PEUGEOT/CITROËN THERMOSTAT REDESIGN TO OVERCOME OVERHEATING ISSUES

Issue Date: 23/09/19 Issue Number: COTB0025B

APPLICATION: Citroën Berlingo, C3, C4, DS3, Peugeot 207, 308, 3008, 5008, Partner

APPLICABLE REFERENCES: BBT102 / BBT481

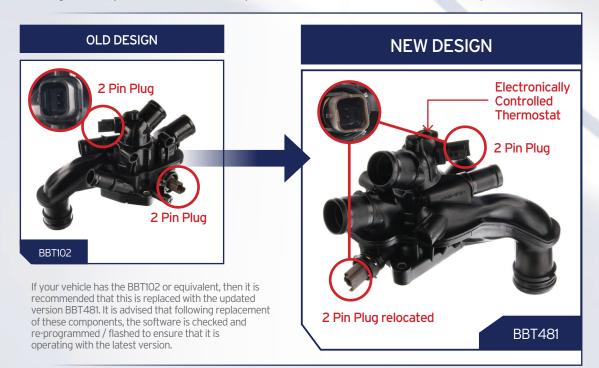
Due to an increase in overheating issues & symptoms such as an erratic temperature gauge, erratic running, radiator fan run-on, or poor heater function in the above vehicles, the O.E.M. have modified the design of the Thermostat housing. Following the O.E. specification, we have replaced the old design BBT102 with the new latest design BBT481. The latest design benefits from an electronically controlled thermostat, a reinforced structure, and a new configuration of sensors.

We have highlighted the key differences below so that you are clear that the latest part, although visually different to what may be on the vehicle, is in fact the correct product.

The modified version has had the lower 2 Pin connector relocated, therefore, a new cable may also be required to carry out the modification.

New Cable: BTS3091 - Thermostat Wiring Harness
